In the Matter of
TEXAS UTILITIES ELECTRIC
COMPANY, et al.

(Comanche Peak Steam
Electric Station,
Units 1 and 2)

TESTIMONY OF NANCY H. WILLIAMS
IN RESPONSE TO CASE QUESTIONS OF
FEB. 22, 1984 TO CYGNA ENERGY SERVICES

FIGURE D2-1

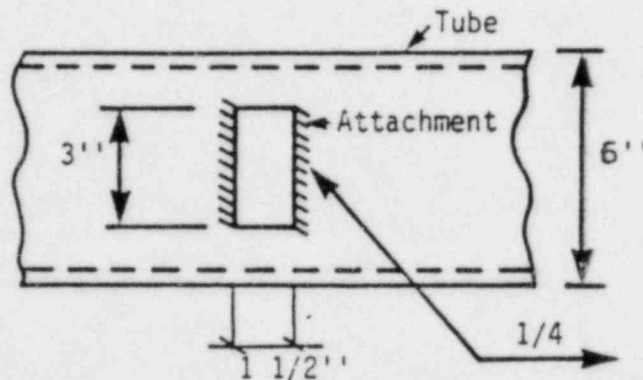
Punching shear check for Support No. RH-1-062-002-S22R.

APPLIED AXIAL LOAD = 5092 LBS.

Figure 1

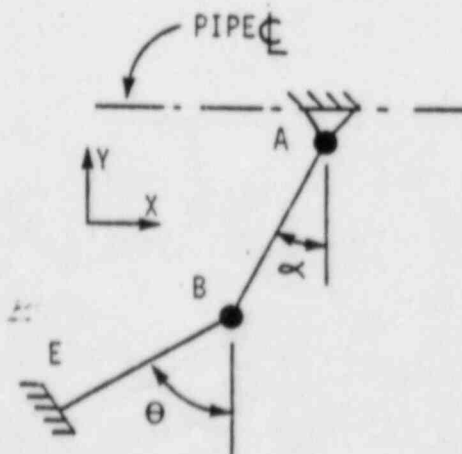
The stability characteristics of a structure under the action of compressive loads can generally be separated into three categories. These include rigid body modes of instability, Euler column buckling, and beam-column effects. For the purposes of discussion, the three support configurations in question (CASE Exhibits 891, 894 and 897) can all be idealized to the basic configuration shown in Figure 1, wherein the x component of reaction at A is provided by frictional clamping forces. For this basic configuration, the rigid body modes of instability generally account for the overall stability characteristics of the entire structure, while Euler column buckling and beam-column effects are confined to the individual members.

The rigid body mode of instability can be initiated in three ways: (1) when the clamping force at A is insufficient to develop the lateral (x) component of frictional force necessary to prevent sliding; (2) when the clamping force at A is insufficient to develop the resisting torque necessary to prevent the clamp from rotating; and (3) for the specific case of alpha equals theta, when the cantilevered member BC does not provide sufficient lateral stiffness at point B to prevent rigid body rotation of member AB.

Euler column buckling of member AB can occur for all values of alpha and theta given in the three exhibits. The correct value of K to be used in evaluating the stability of member AB is 1.0, since the member is pinned at both ends and can therefore only develop axial loads. Similarly, Euler column buckling can occur in member BC but only when alpha equals theta. The correct value of K to be used in evaluating the stability of this member is 2.0 since the member is fixed at one end and free at the other.

Check Flange Bending
 Support No. SI-1-079-001-5325

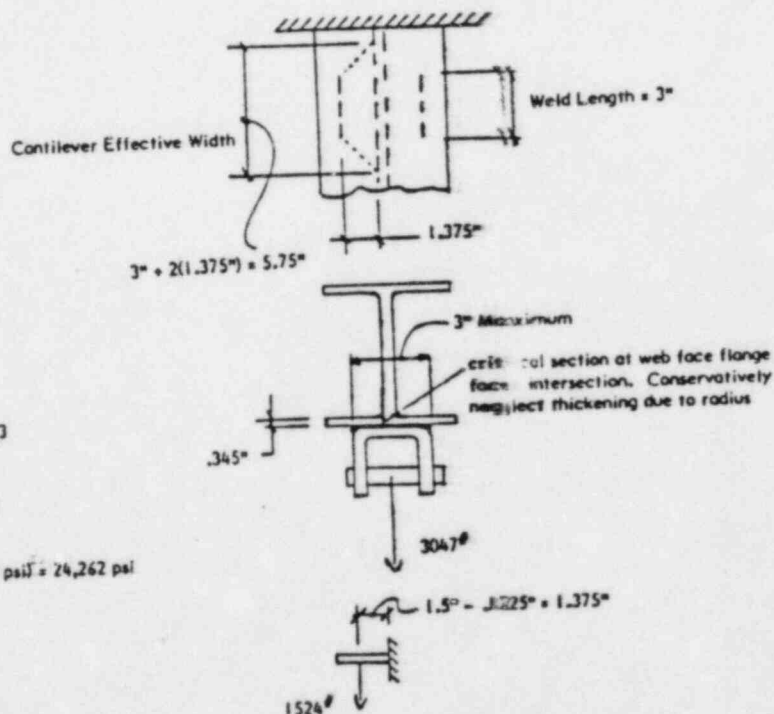
The calculation sheet attached to Exhibit 893 states that the weldment between the rear bracket and the beam flange was changed from a fillet to a flare/bevel weld. This fillet-to-flare change results in a 90 degree re-orientation of the weld lines, from perpendicular-to-parallel to the web of the wide flange. Did Cygna evaluate the additional loads on the flange?

Cygna judged that this re-orientation would not cause an overstress in the flange. The following calculation verifies that judgement:

$$S = \frac{bh^2}{6} = \frac{5.75}{6} (.345)^2 = .114 \text{ in}^3$$

Exhibit 891 (Support SI-1-325-002-S22R)

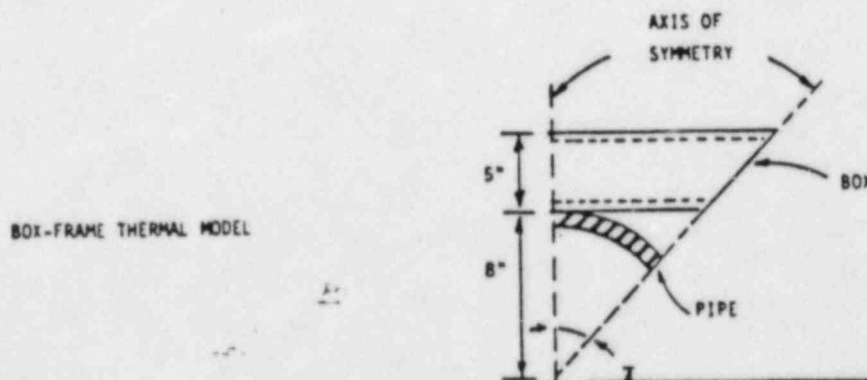
Exhibit 891 shows a box-frame enclosing a 16" diameter pipe. The design details specify a zero gap between the pipe and frame at the four points of contact. Cygna reviewers evaluated this configuration and judged that the thermal stresses would be acceptable.

To address some concerns raised during the ASLB hearing regarding this issue, Cygna performed a finite element analysis of the frame/pipe with zero gaps. Figure D15-1 shows the model. The pipe was heated to 350°F ($T = 280^{\circ}\text{F}$) and the flexibility of both the pipe and frame were considered.

FIGURE D15-2

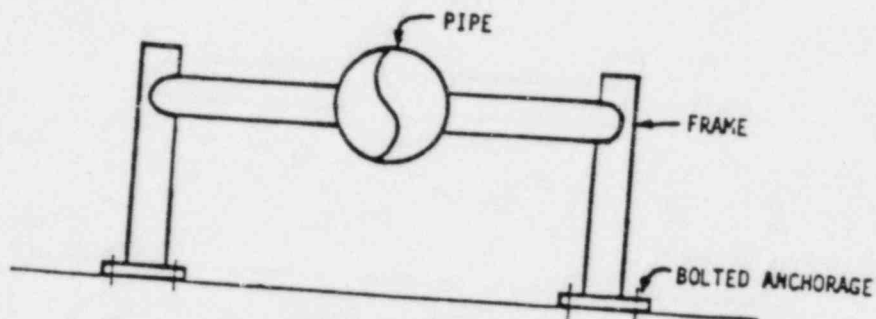
Exhibits 898 and 900 show two variations of framed supports where the pipe is welded to diametrically opposed trunions which form the horizontal member of the frame. Figure D15-2 illustrates this configuration.

Cynga reviewers considered the effect of pipe thermal expansion to have negligible impact on the support design since the stresses induced in the support result from constraint of free end displacements. Under these conditions the Code allows a 200% increase in allowable stress when the mechanical levels are combined with the effects of the pipe thermal expansion.

To demonstrate this conclusion, Cynga performed a hand calculation for CASE Exhibit 898 (See Attachment D15-1) which incorporate the effects of pipe thermal expansion with mechanical loads. The results of this calculation show that all stresses in the frame and base plate are below the allowables.

FIGURE D15-3

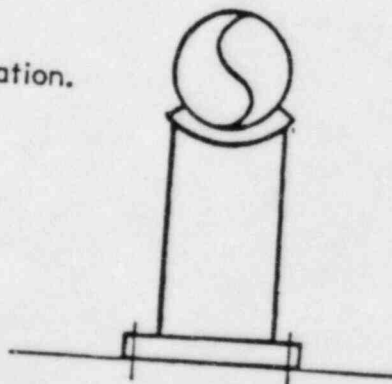
Figure D15-3 illustrates this configuration.

By inspection, thermal radial growth of the pipe is primarily unrestrained. A secondary restraint will develop at the bimetallic weld due to thermal gradients and the material differences. Cygna's reviewers judged the effect of this secondary restraint to be negligible.

Figure W3-2

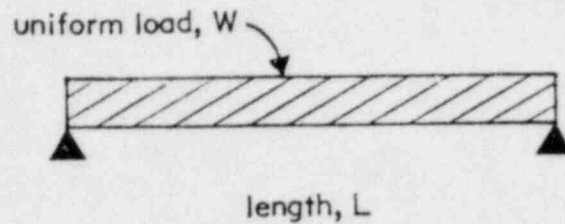
- The effect on thermal, pressure and deadweight stresses as the pipe wall thickness decreases.
- The effect on seismic stresses, which are not linearly proportional to the change in wall thickness.

The maximum deadweight bending stress (σ_D) in Figure W3-2 is:

Equation (7) shows that deadweight stresses due to other dead loads, such as insulation, would increase as the wall thickness decreases. This is because only the moment of inertia would change.

Pipe stresses induced by pipe deadweight are unchanged by a change in wall thickness.

Exhibit 902

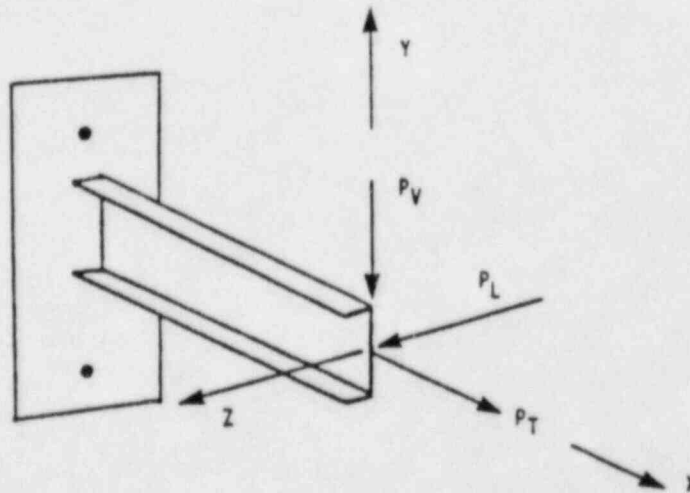
The calculation in question concerns the analysis of the two-bolt baseplate of a Detail "E" which was installed on a riser and is utilized as a three-way restraint.

Gibbs & Hill's analysis considered a rigid baseplate which was analyzed to resist rotations about the Y and Z axis. Gibbs & Hill's analysis showed that compression against the concrete provides sufficient resistance in conjunction with the tension in the anchor bolts.

Gibbs & Hill Revised Calculation	= .584
Cygna Baseplate Analysis	= .464
